## ORIGINATION FORM

### Proposed Revisions to a Standard Plans Index (Please provide all information — Incomplete forms will be returned)

Index Number: 455-020

Index Title: 20" Square Prestressed Concrete Pile

LAST REVISION 01/01/12	DESCRIPTION:	 FY 2020-21 STANDARD PLANS	<b>20" SQUARE PRESTRESSED CONCRETE PILE</b>	INDEX 455-020	SHEET 1 of 1
---------------------------	--------------	----------------------------------	---	------------------	-----------------

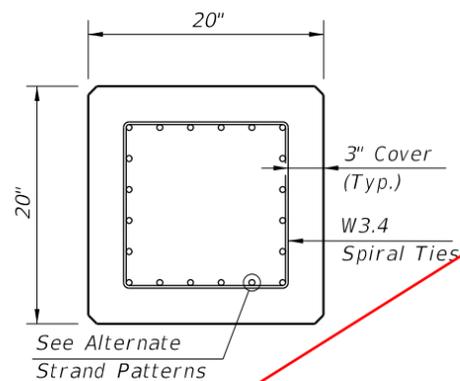
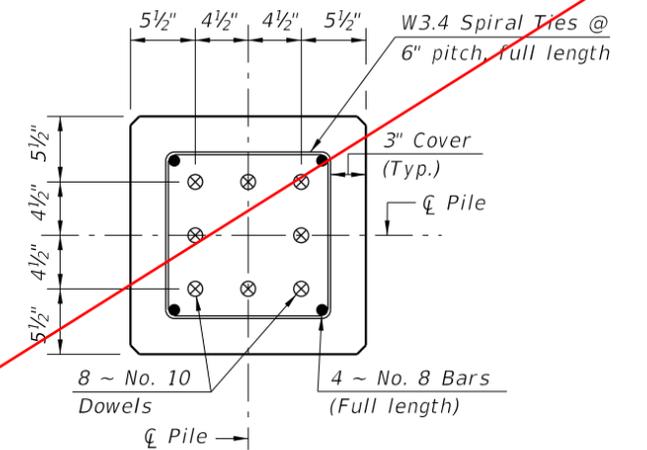
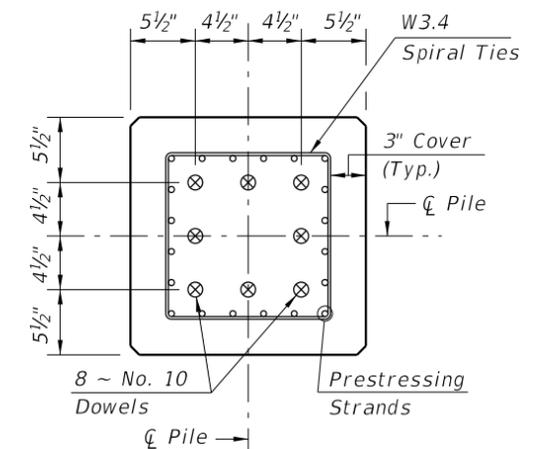
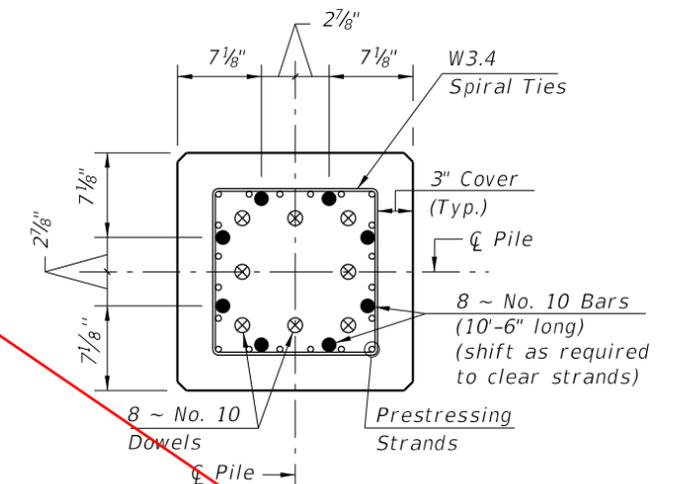
Delete Index (Sheet 1 of 1)

Uncommon size, not used; therefore the forms are not readily available should it be called for. Costs more than a 24" pile.

**DELETE ENTIRE INDEX\*\*** See Note 4 on Index 455-002
